# CITY OF ALBUQUERQUE

**Re: National Electric, 2200 Midtown Plaza NE  
2200 Midtown Pl NE  
Request Permanent C.O. - Accepted  
Engineer's Stamp Dated 8-1-15 (File: G16D095E)  
Certification dated: 7-22-16**

**Re: National Electric  
Grading and Drainage Plan  
Engineer's Stamp Date 8/1/2015 (G16/D095E)**

RE: **National Electric, 2200 Midtown Plaza NE**  
**Grading and Drainage Plan**  
**Engineer's Stamp Dated 5-06-15 (File: G16-D095E)**

**RE: Revised Grading Plan (G16-D095E)  
National Electric  
Albuquerque, New Mexico**

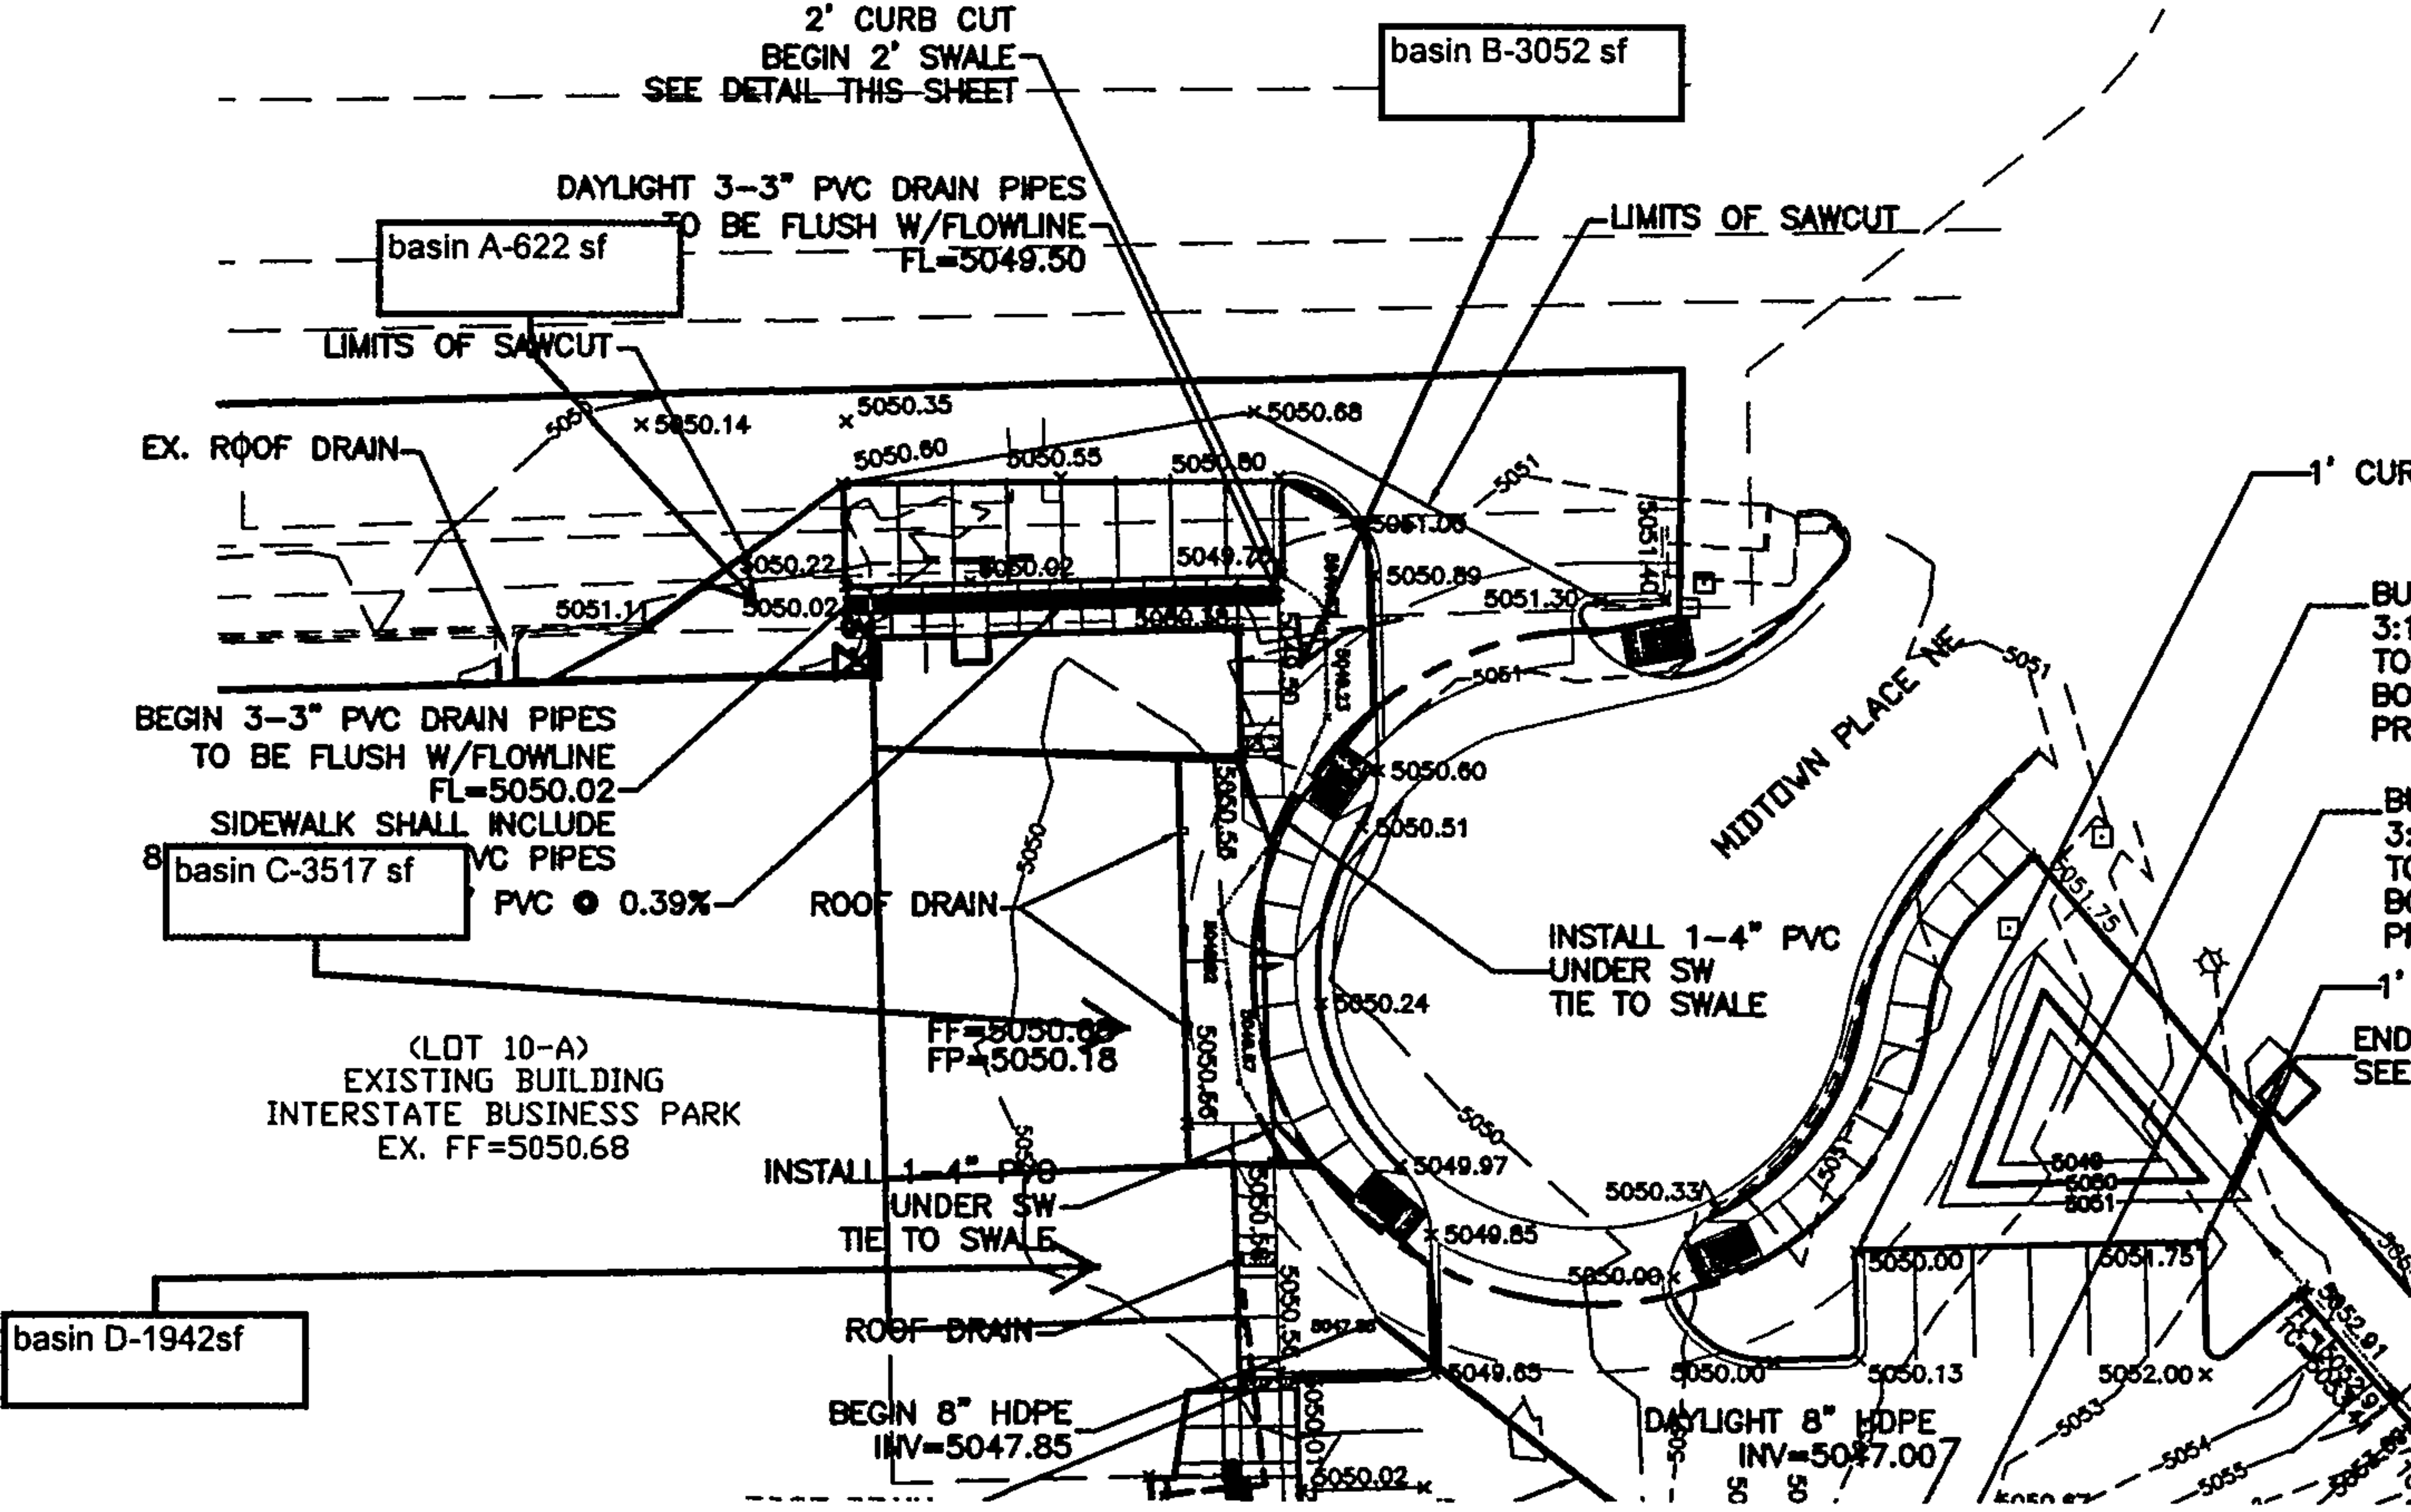
Based upon the information provided in your submittal received 5-06-15, the above referenced plan cannot be approved for Building Permit until the following comments are addressed:

- 1) Show basin boundaries for the provided basin computations, and show where new improvements end and tie into existing facilities.
- 2) Label existing contours and the new contours for the ponds.
- 3) Show swale from 5049.85 spot elevation at entryway to the pond on the north side of the site.
- 4) Show existing and new roof drains.
- 5) In the "Drainage Narrative", mention overall acreage of the site, and explain that historical flow patterns for the site remain the same if this is the case. Discuss the off-site flows from Midtown Place that the site is accepting, and reference the prior drainage report. Mention that the new retention ponds retain the volume of increased runoff from existing conditions.
- 6) Label 100-year storm flow that each of the new on-site pipes is conveying and the pipe slope. Demonstrate capacities.

The purpose of this letter is to accompany the enclosed revised grading plan. The plan has been revised to address your written comments dated May 28, 2015. The following is an answer to the corresponding comment number to your letter.

1. We have provided a basin map and labeled project limits
2. We have labeled the pond contours
3. We have shown a swap form the 5049.85 at entry to the pond on north side of site.
4. We have shown the roof drains
5. We have updated the drainage narrative to discuss upland flows and retention volumes.
6. We have labeled the flows in the pips and included calculations for capacity in the
